Wisconsin Department of Transportation

Proposal #14: 1130-32-71, WISC 2018 011
Green Bay - Oconto
Lineville Road – Norfield Road
USH 41
Brown County

This is Addendum No. 01, which provides for the following:

ADDENDUM NO. 01

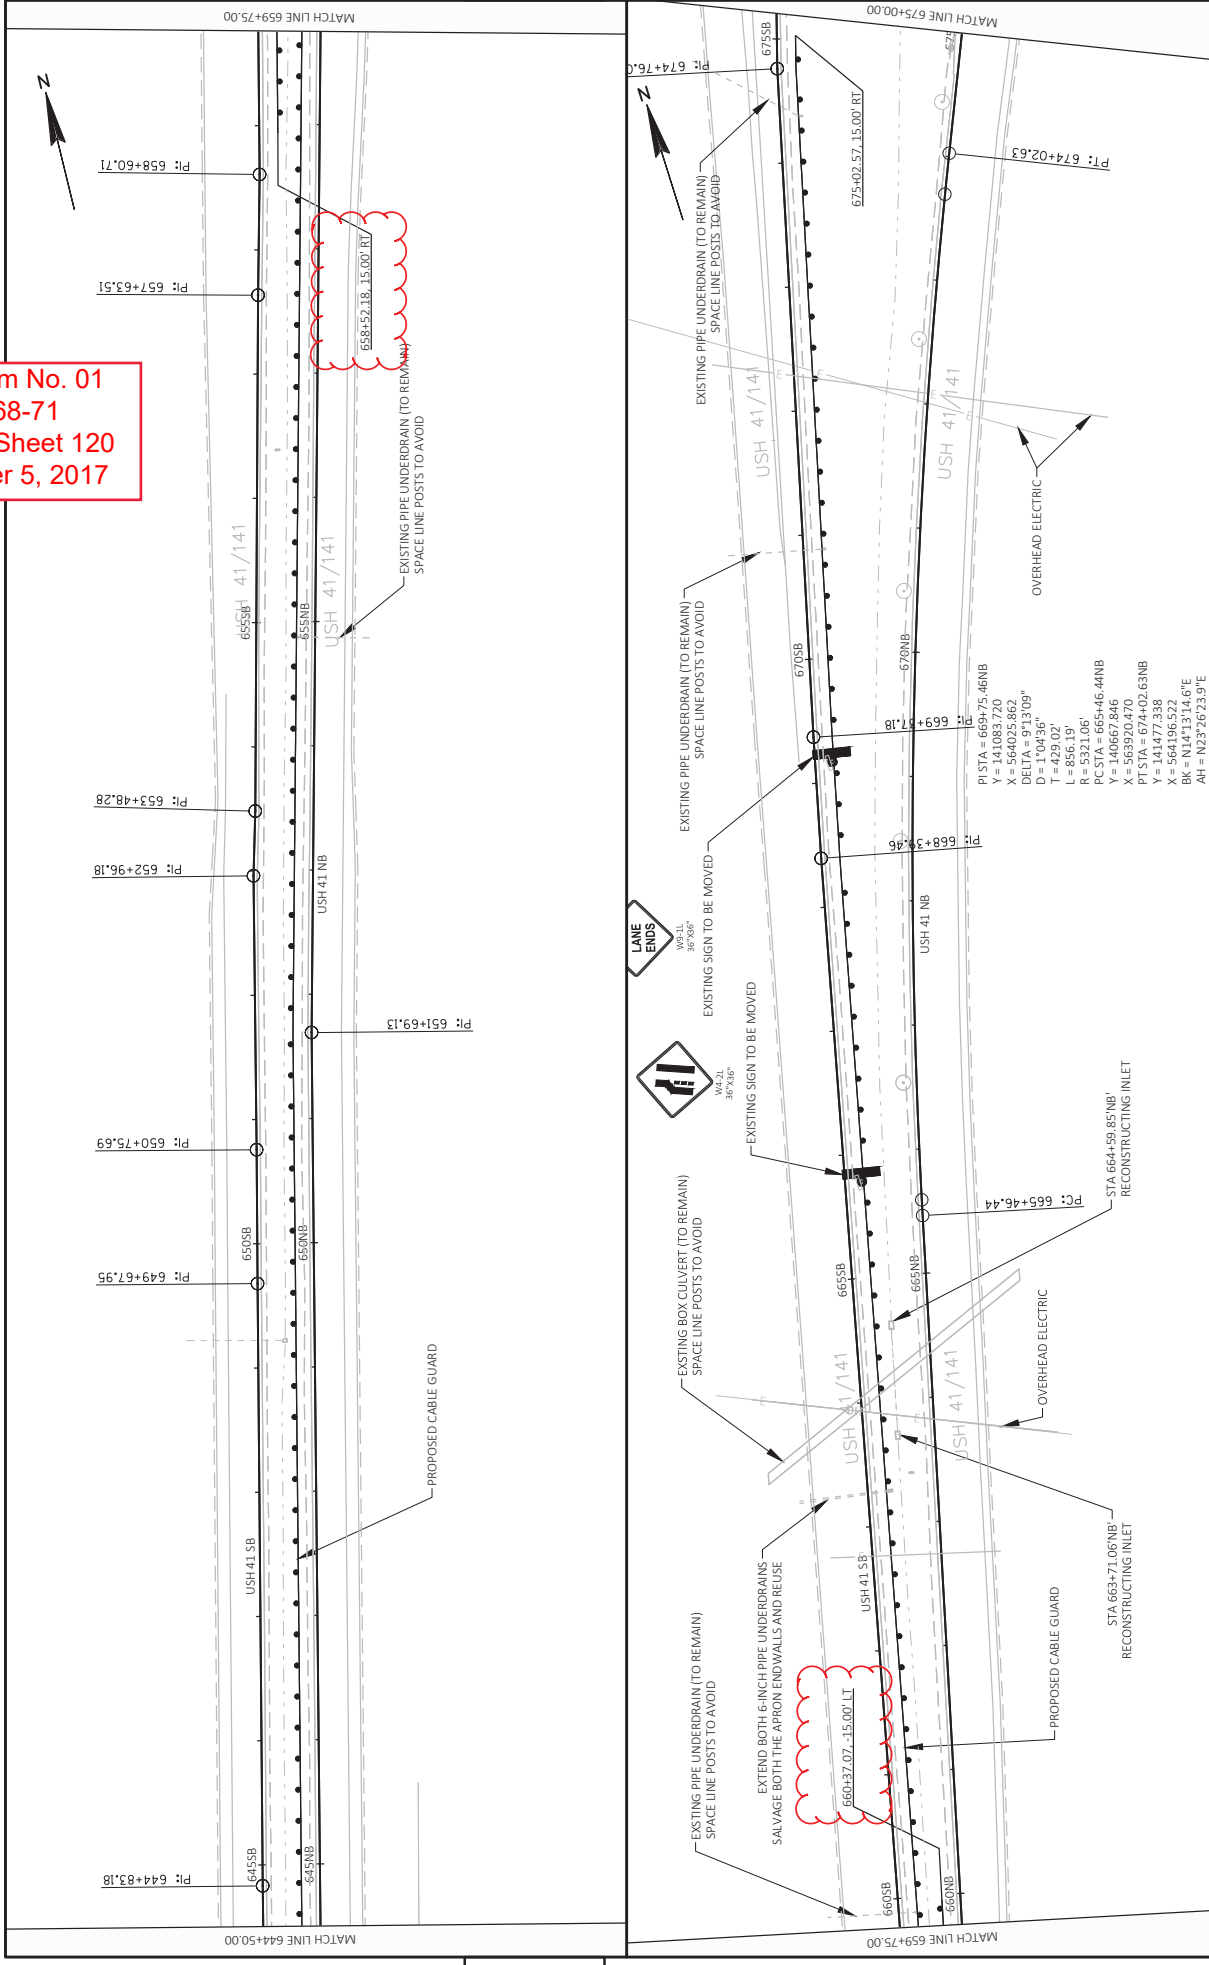
118	Plan Sheet (change stationing for Proposed Cable Guard)
119	Plan Sheet (change stationing for Proposed Cable Guard)
120	Plan Sheet (change stationing for Proposed Cable Guard)
121	Plan Sheet (change stationing for Proposed Cable Guard)
123	Plan Sheet (change stationing for Proposed Cable Guard)
124	Plan Sheet (change stationing for Proposed Cable Guard)
